SmartSolar MPPT 250/100-Tr VE.Can issue with capacitor C609

Technote July 2022

Step 1.

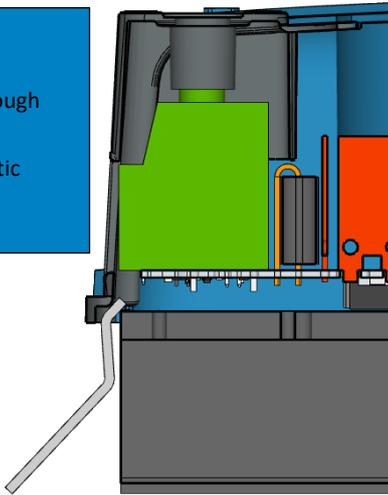
Slide the tool through the gap between heatsink and plastic insert.

Step 2.

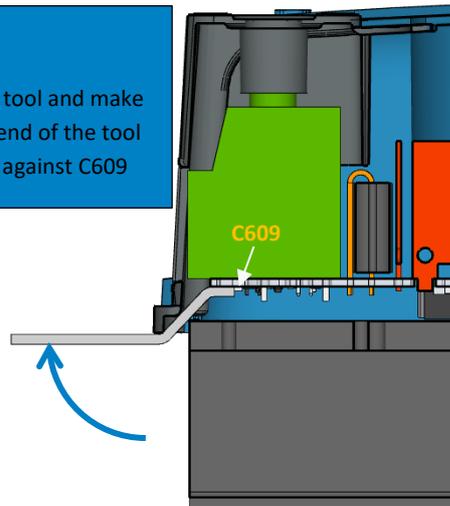
Level the tool and make sure the end of the tool is resting against C609

Step 3.

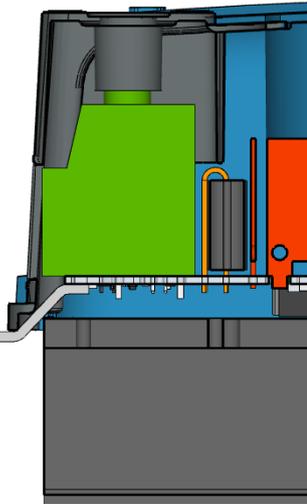
Tap the tool with a hammer to break off the capacitor.
